Re: Westtown School – 975 Westtown Road  
Revised Conditional Use Application Materials – Athletic Field Lighting

**Responses to Cedarville Engineering Review Letter of April 14, 2023 (REISSUE):**

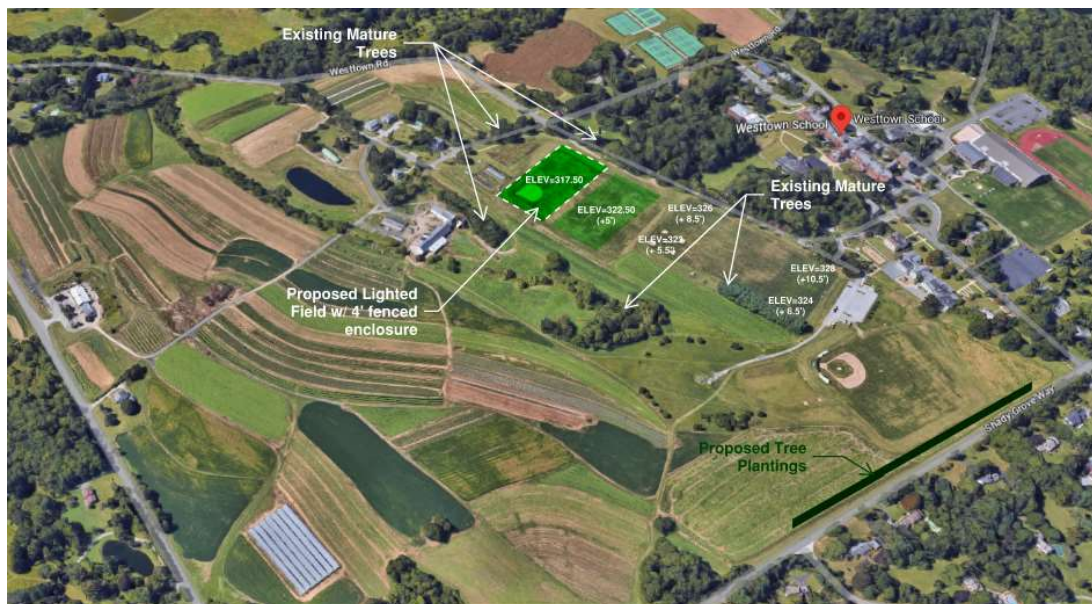
- *The acoustics study letter prepared by Eberbach Acoustics Consulting Consultants shall be revised to address the following:*
  - *The referenced study indicates that noise measurements were based upon an assumption of a soccer practice of up to 56 players. The proposed parking lot proposes a total of 84 parking spaces required, resulting from the potential of a higher intensity use than assumed in the study. The study shall be updated, and shall be revised to be based upon full occupancy of the proposed parking space and existing spaces located to the east of the existing multipurpose fields, adjacent to the proposed fields.*

The number of players/participants referenced in the acoustics study is 56, which is a reasonable estimate of the number of people that will be utilizing the illuminated athletic field at any point in time. Even if the number of players/participants is doubled to 112, the noise produced would be an increase of only 3 decibels, as described in paragraph 4 of the January 26 ,2023 letter from Everbach Acoustics Consulting. The number of proposed parking spaces is not necessarily representative of the number of people utilizing the illuminated athletic field at any given point in time, as the parking area is designed to accommodate the use of both athletic fields during daytime use. However, even if every car contained two players/participants and the total of 84 parking spaces produced 168 players/participants, the total increase in field noise would only be 4.77 decibels higher than the 56 players/participants quoted in the study, resulting in a reasonable noise level on the Property.
